ADDENDUM NO. 2
TO THE BID DOCUMENTS FOR
ARROWHEAD REGIONAL MEDICAL CENTER ONCOLOGY INFUSION CLINIC

DATE: September 12, 2019

ADDENDUM NO. 02
TO THE CONSTRUCTION DOCUMENTS BID PACKAGE

Client: Arrowhead Regional Medical Center
Project: Oncology-Ambulatory Clinic
SHA Project No.: 18242.100
Date: September 12, 2019

A3 SECOND FLOOR DEMOLITION PLAN

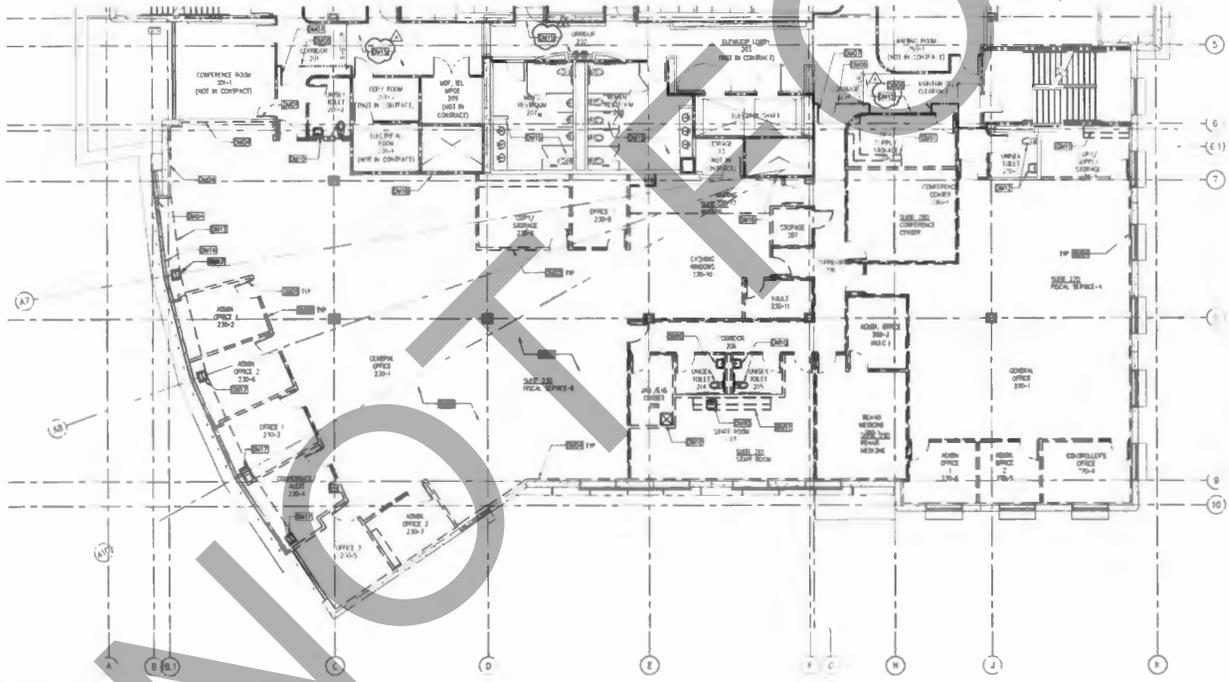
A111 Existing room names added to the corridor that is to the north of the project area, scope revised to indicate partial demolition of the ceiling in this corridor.

General Note added to sheet regarding accommodations for equipment or material deliveries and trash removal from the project area.

002.5	Sheet A111 DM15 shows removal of ceiling in restrooms 207 & 208. Sheet M122 shows these areas as "not in contract". Please confirm these areas are in the scope of work.	Keynote DM15 indicates to DEMOLISH EXISTING CEILING AS REQUIRED BY NEW MECHANICAL WORK ONLY. Coordinate with scope shown on Mechanical drawings. M122 should NOT indicate "NOT IN SCOPE". See revised Mechanical sheets attached.

007.1	Keynote DM04 on sheet A111 Demolition Plan calls to "Demolish Existing Gypsum Board On One Side Only, Protect Framing In Place" along the West, South & East perimeter walls, but keynote FP06 on sheet A122 Floor Plan - Area A calls for "Existing Gypsum Board Furring to Remain, Protect in Place. Please advise if existing gypsum board along the perimeter wall is to remain, or to be demolished and replaced with new framing and drywall.	Existing gypsum board along all perimeter walls is to be demolished. FP06 on sheets A122 and A123 has been revised to indicated existing framing with new 5/8" gypsum wall board.

A4 PARTIAL FLOOR PLAN - AREA 'A'

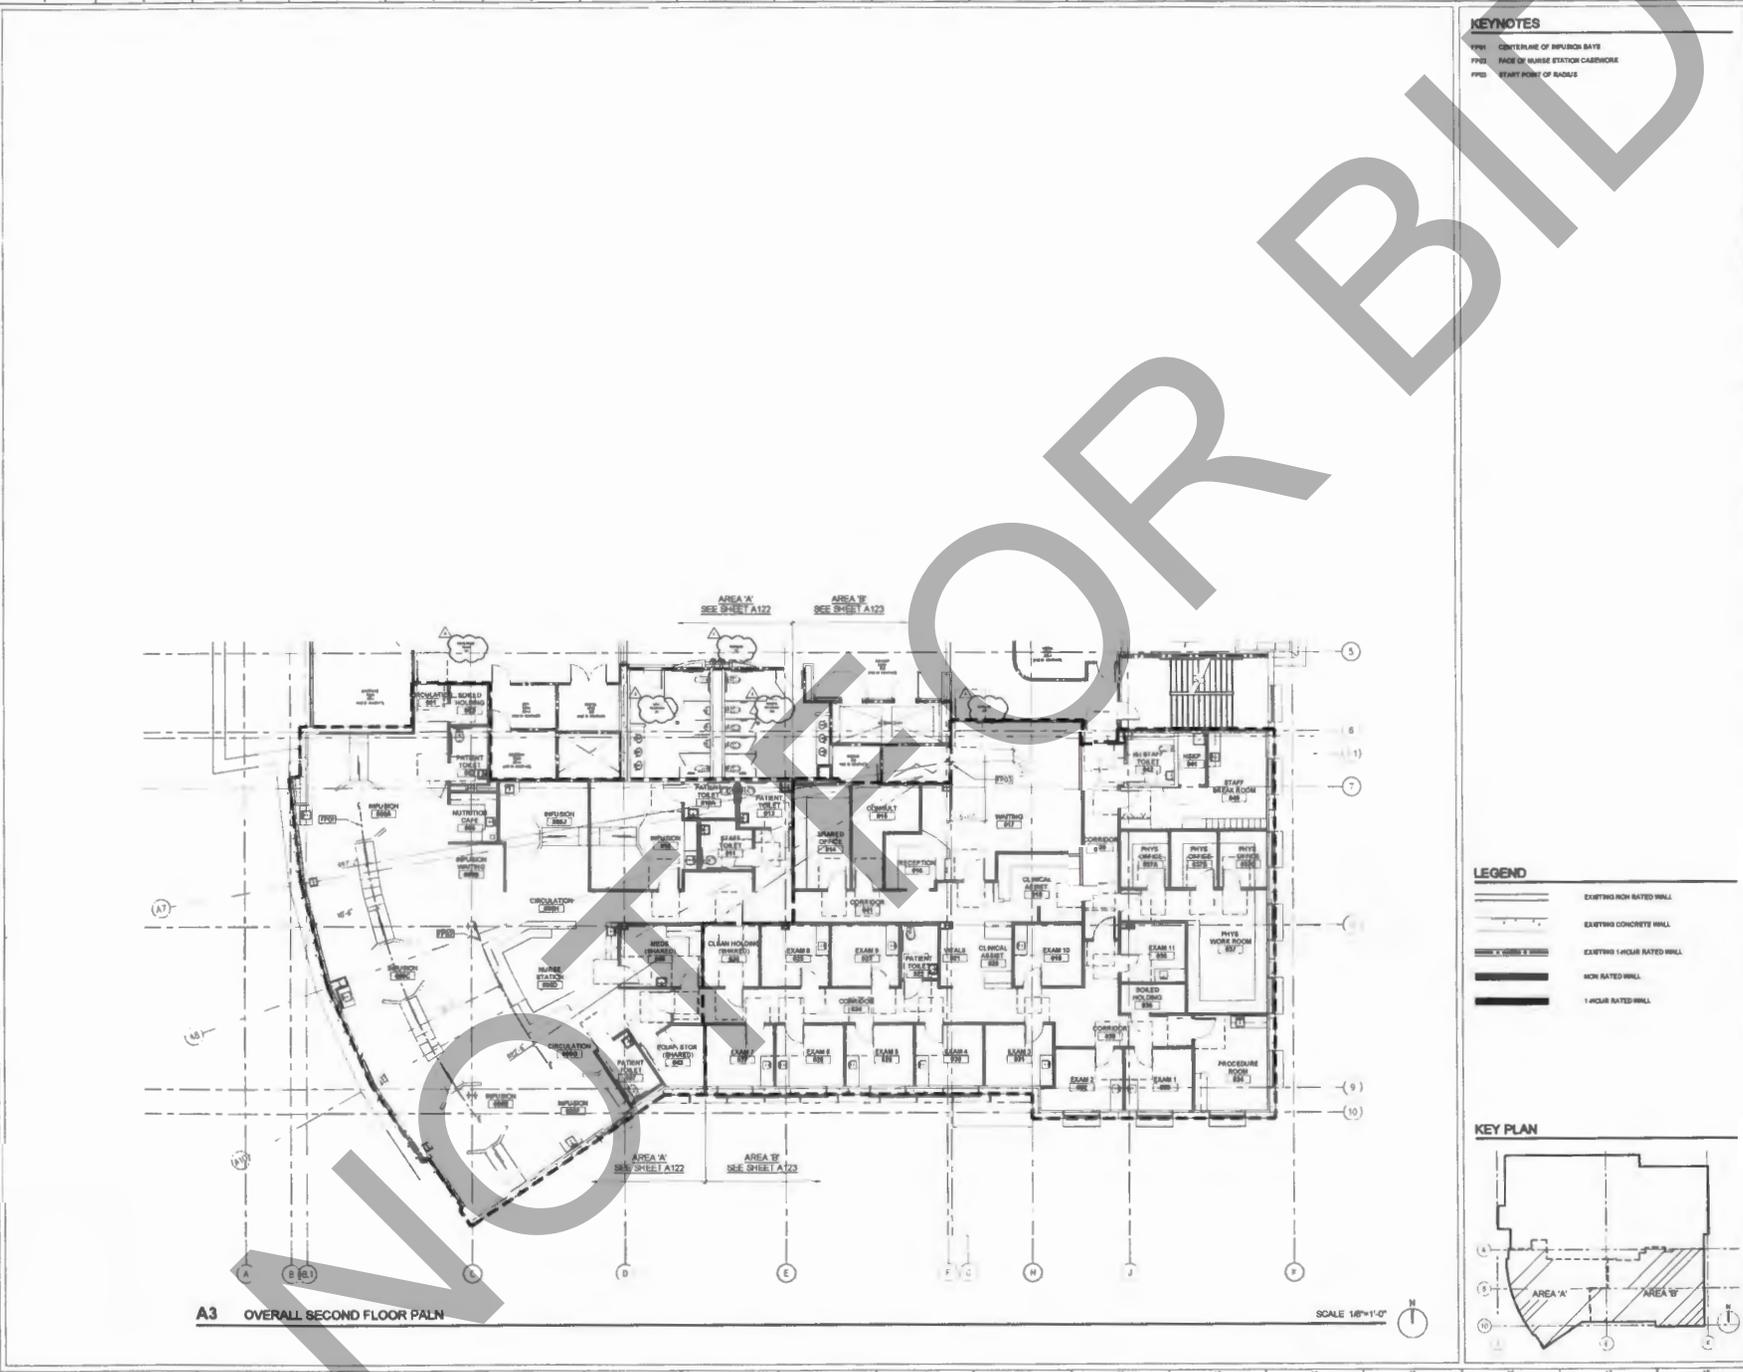
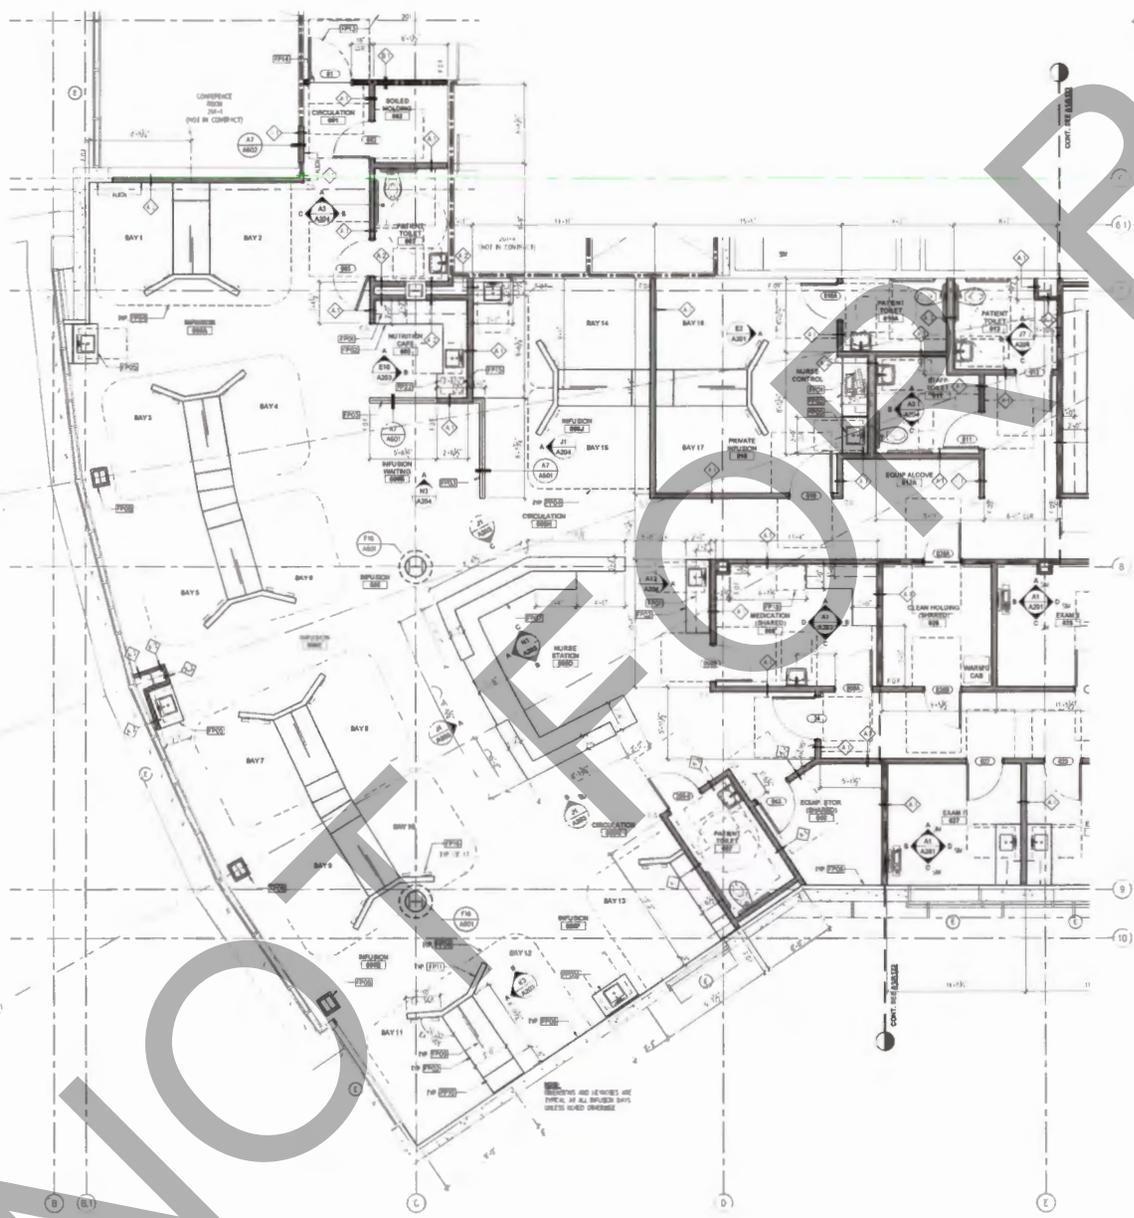
A122 Keynote FP06 revised to indicate new gypsum board at existing framing.

General Note regarding Owner Furnished Items added to General Notes.

SHEET TITLE
FLOOR PLAN - AREA 'B'

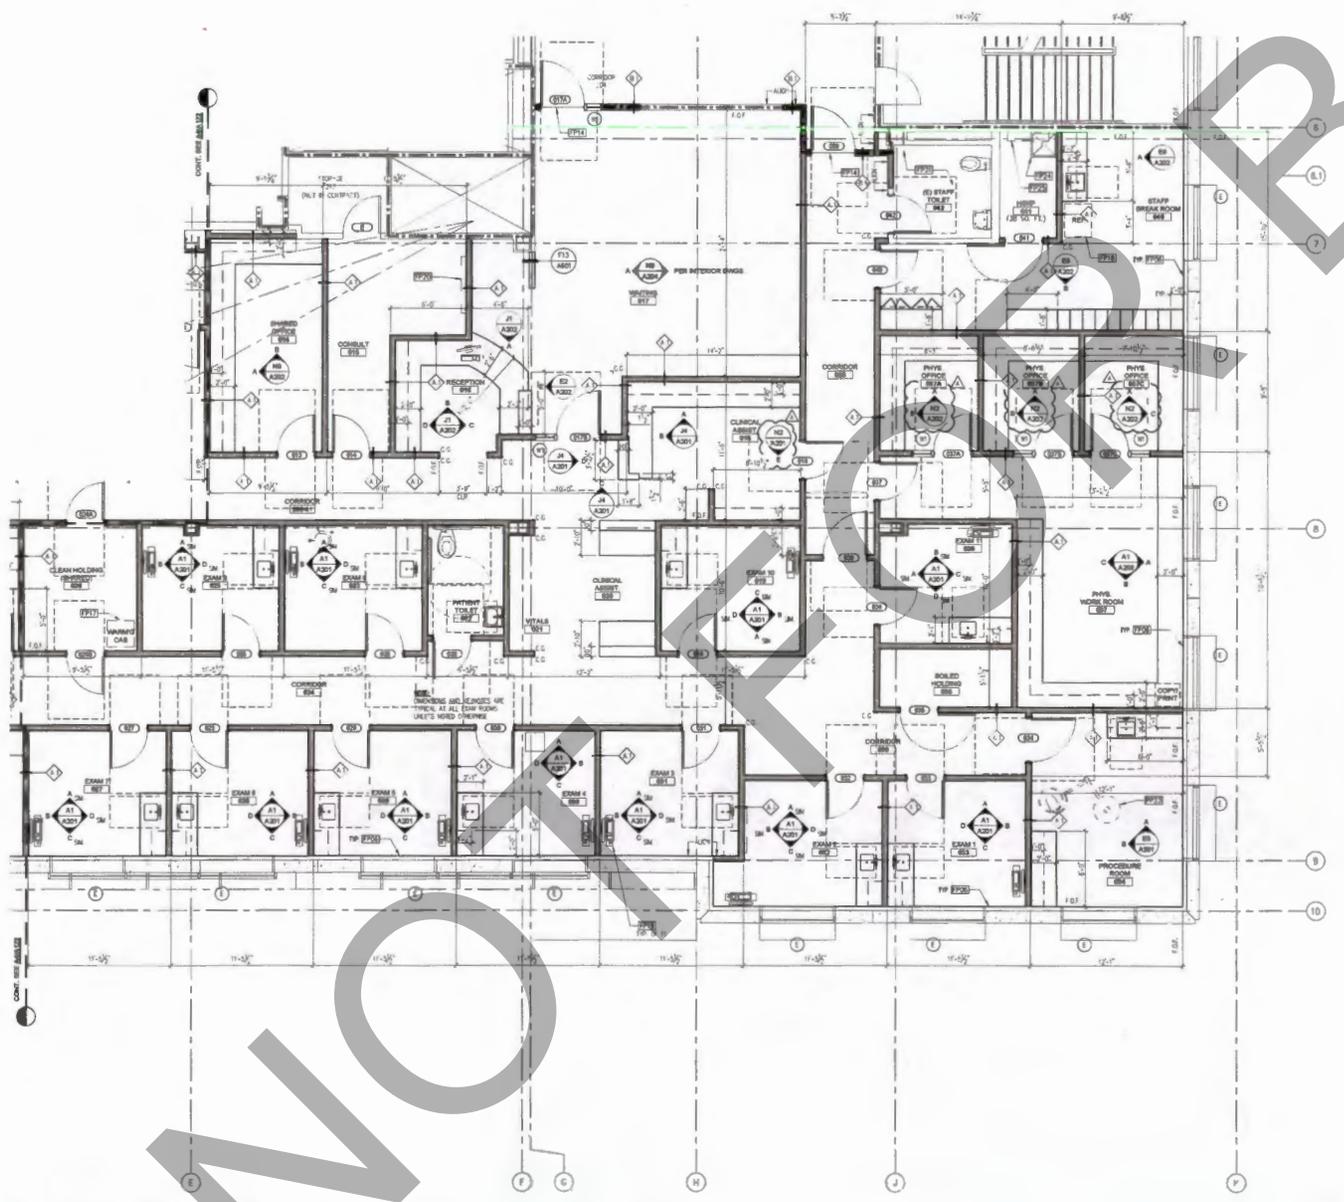
- A123** Keynote FP06 revised to indicate new gypsum board at existing framing.
- A131** General Note added to sheet regarding patching back of existing ceilings in corridor.
General Note regarding Owner Furnished Items added to General Notes.

SHEET NUMBER: **A201**

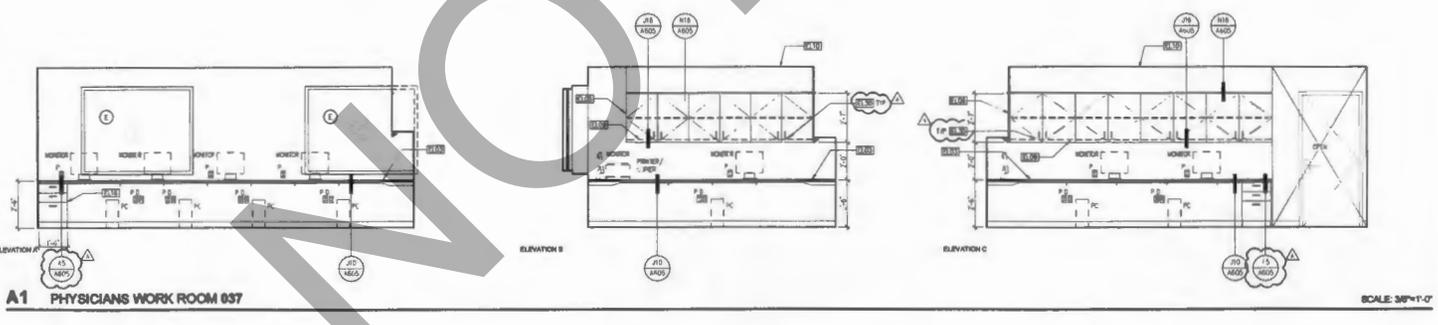
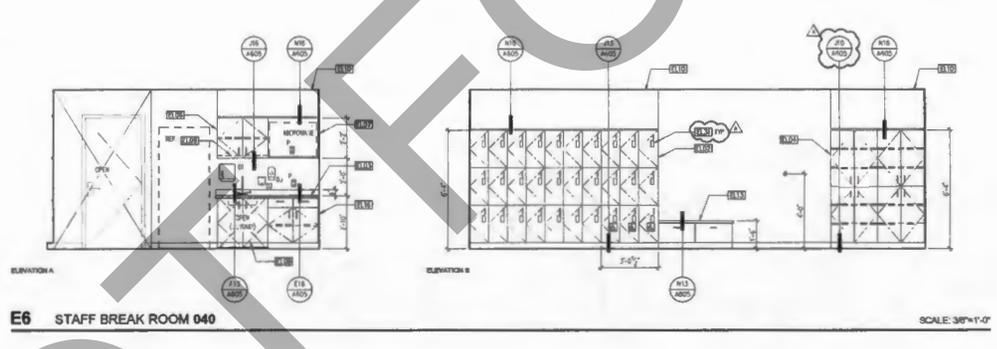
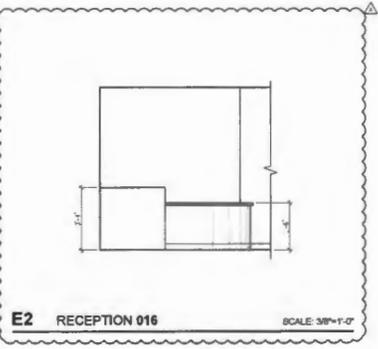
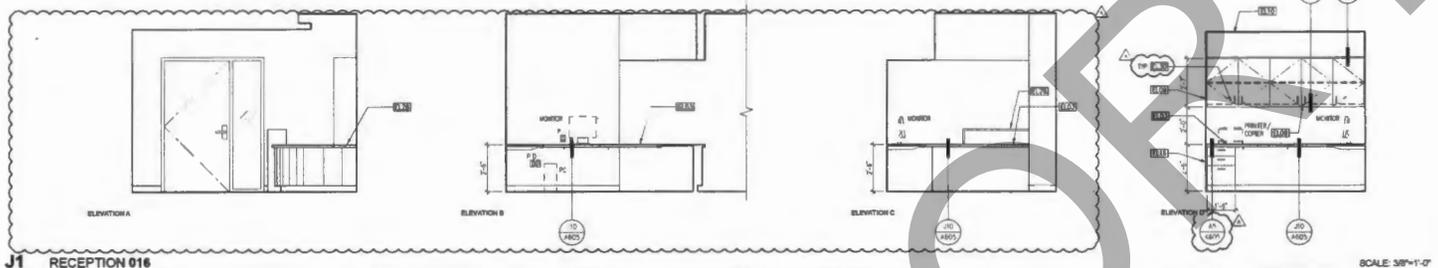
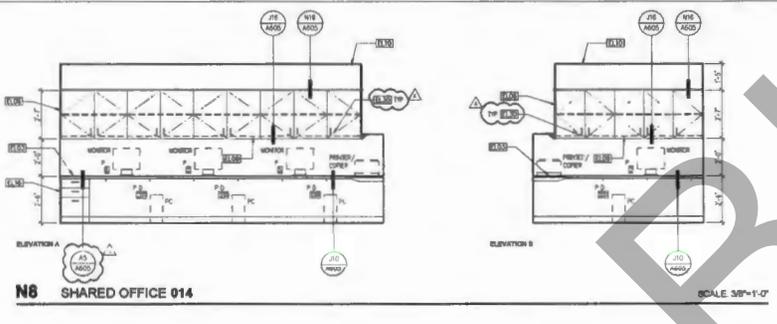
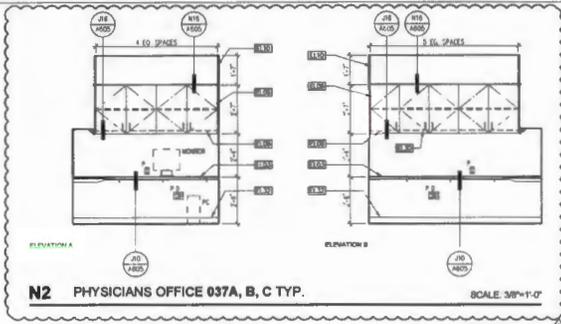
- A201** Clinical Assistant 018 Interior Elevation E added to sheet at N2/-.
Cabinet locks added to various elevations and Keynote EL30 added to Keynotes.
General Note prohibiting cabinet locks at accessible sink aprons added to General Notes.
Detail callout revised to reference correct detail.

SHEET NUMBER
A202

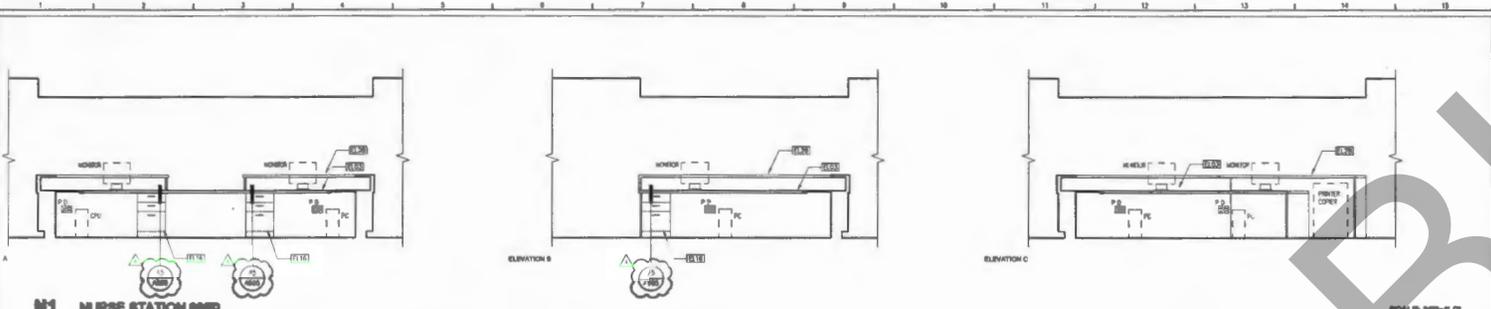
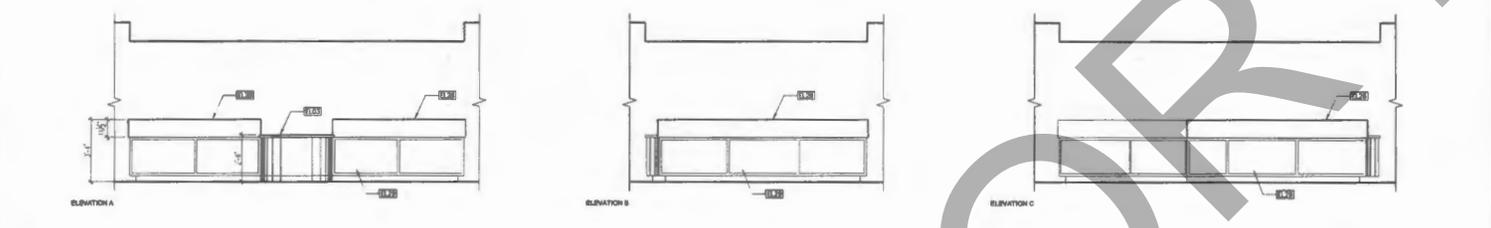
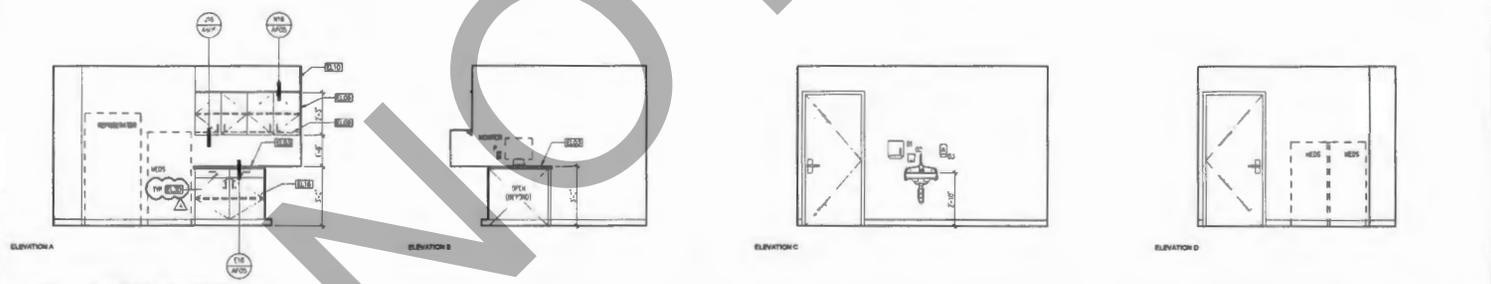
- A202** Physician's Office 037A, B, C Interior Elevations A & B added to sheet at N2/-.
Cabinet locks added to various elevations and Keynote EL30 added to Keynotes.
General Note prohibiting cabinet locks at accessible sink aprons added to General Notes.
Elevation E6 revised to show padlock hasp at plastic laminate lockers.
Elevation J1 revised to match floor plan.
Various detail callouts revised to reference correct detail.
Elevation E2/- added to sheet.

004.1	Elevation E6/A202 shows plastic laminate lockers per Keynote EL02 and Section 105060, but section 090000 Finish Material Legend identifies the lockers as LKR-1 Metal Lockers. Please clarify.	The lockers are to be Plastic Laminate, Metal Lockers have been removed from Specification Section 090000. Please use Specification Section 105060 per architectural drawings. See revised Specification Sections.
